Service - Info

Unit : Chassis TV 9.xx

No.: 245

Concern:

No.: 246

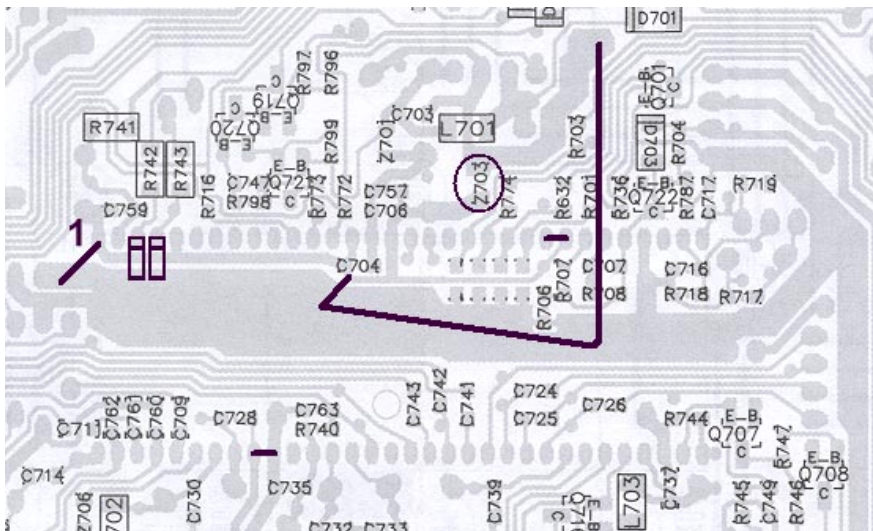
Failure of the horizontal deflection Q 304

Following parts have to be componented, controled or removed:

- 1.) A cap cable high voltage - transformer diode split has to be componented
- 2.) The software IC 902 has to be changed through the latest version
- 3.) A circuit connection has to be soldered in from Pin 1 / IC 701 to ground (look the sketch)
- 4.) A circuit connection has to be soldered in from C 704 to ground (look the sketch)
- 5.) The chip Z 703 has to be removed
- 6.) A circuit connection has to be componented like the sketch (six centimetre long)
- 7.) A circuit connection has to be soldered in from IC 701 / Pin 24 to Pin 25
- 8.) A circuit connection has to be soldered in from IC 701 / Pin 55 to Pin 56
- 9.) Two Diode BZT55C 5,6V have to be soldered in from IC 701 / Pin 3 and 4 to ground (anode to ground)

Attention: The modification's was already integrated in production, therefore a modification isn't necessary in all cases.
The changing of IC 902 is only necessary, if the Diode BZT55C wasn't componented in pro duction.

No.: 252

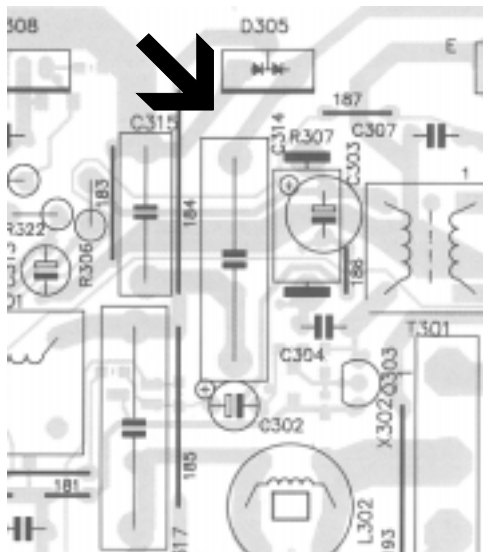
Concern: High frequency whistling

Remedy: The high frequency whistling may be caused by coming into contact of the fitting clip / diode D 305 with the capacitor in position C 314. For remedy the capacitor in position C 314 has to be replaced by a smaller version.

Circuit diagramm / wiring side IC 701:

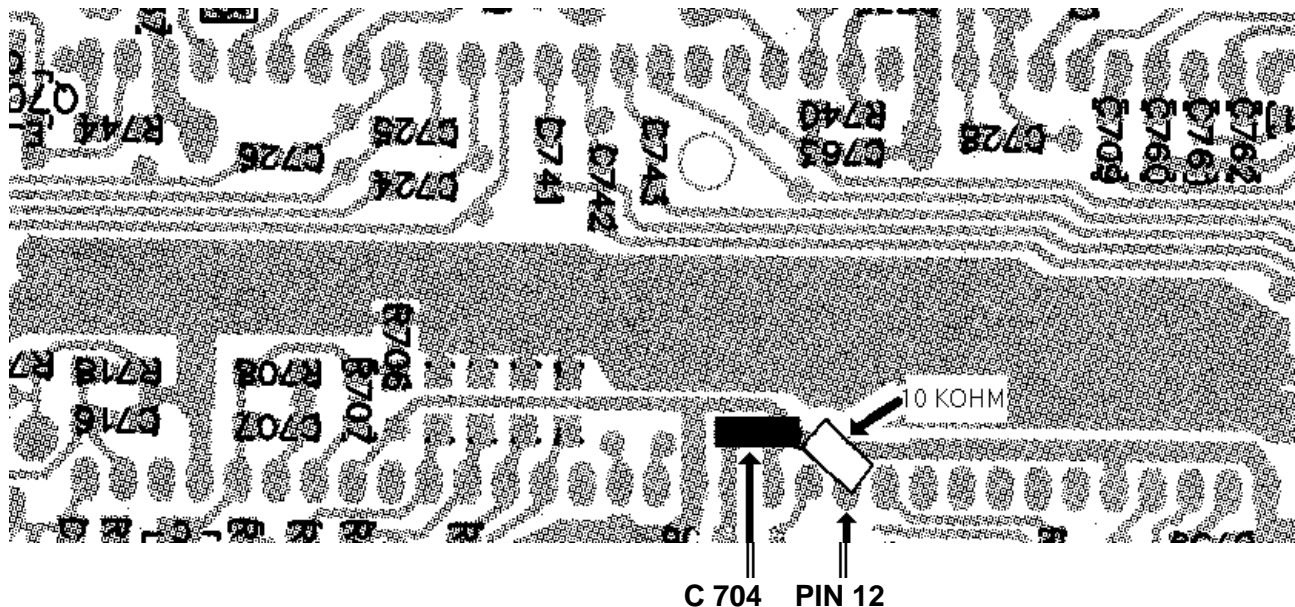
Performance improvement concerning IC VDP 31XX (IC701)

One 10k Ω chip resistor has to be componented additional between pin 12 / IC 701 and the chip capacitor C 704 (use the printed line to Pin 5 and Pin 1 from IC 701).

Main p.c.b. / IC 701 (wiring side):

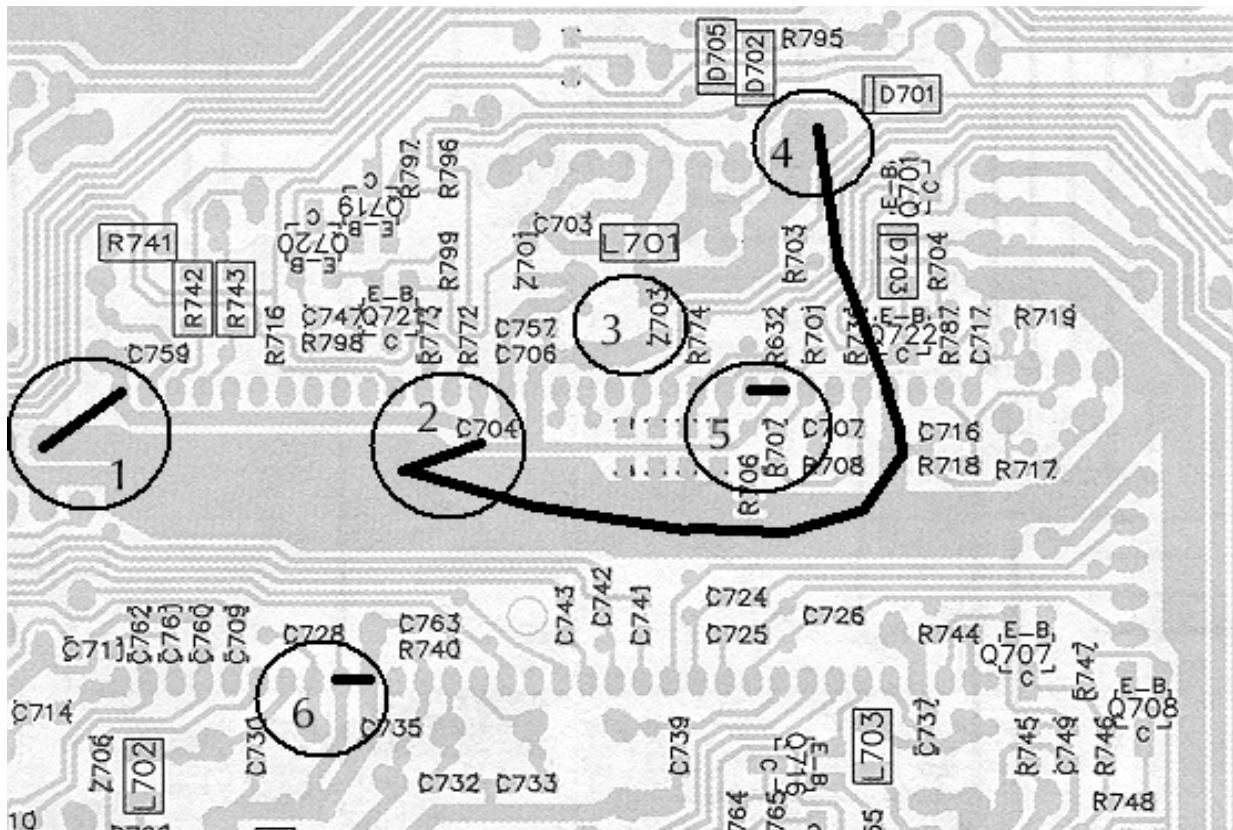
Concern: Improvement of the immunity from static discharge.

| ❶ Short circuit connection Pin 1 IC 701 \Rightarrow ground | ❷ Short circuit connection C 704 \Rightarrow ground |
| ❸ Chip „Z 703“ has to be removed | ❹ Short circuit connection, laying according to below declared diagram (lenght 60 mm) |
| ❺ Short circuit connection IC 701

Pin 24 \Rightarrow Pin 25 | ❻ Short circuit connection IC 701
Pin 55 \Rightarrow Pin 56 |

Attention: The modification 1, 2 and 5 are already integrated up to board number 0109040.

No.: 243

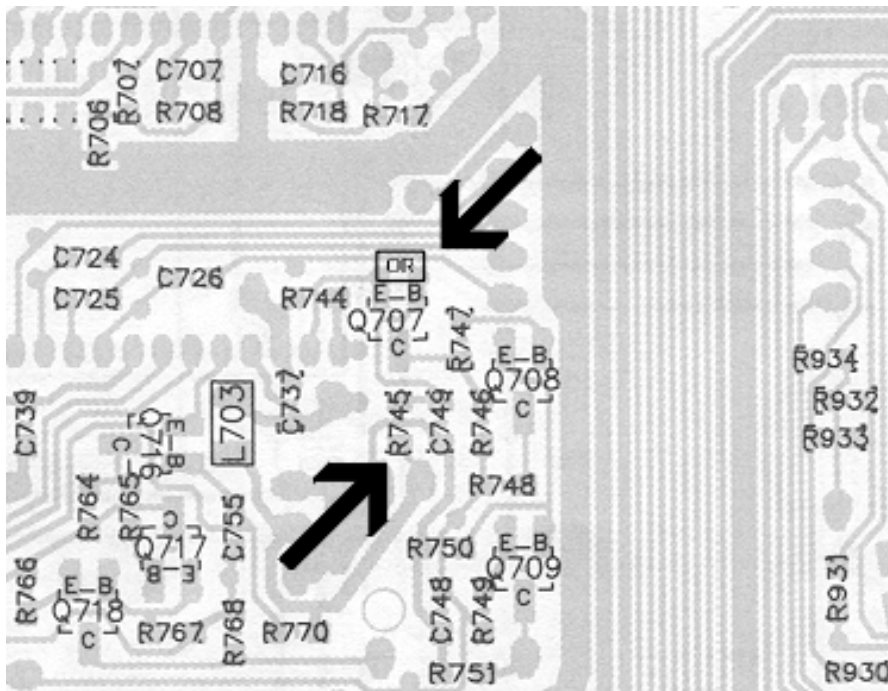
Concern: Vertical stripes at the right side behind the OSD

- The chip resistor in position CR 745 (100 Ω) has to be removed and replaced by a 0 Ω version
- Between emitter and basis from transistor a 0 Ω chip resistor has to be componented additional (like illustration)
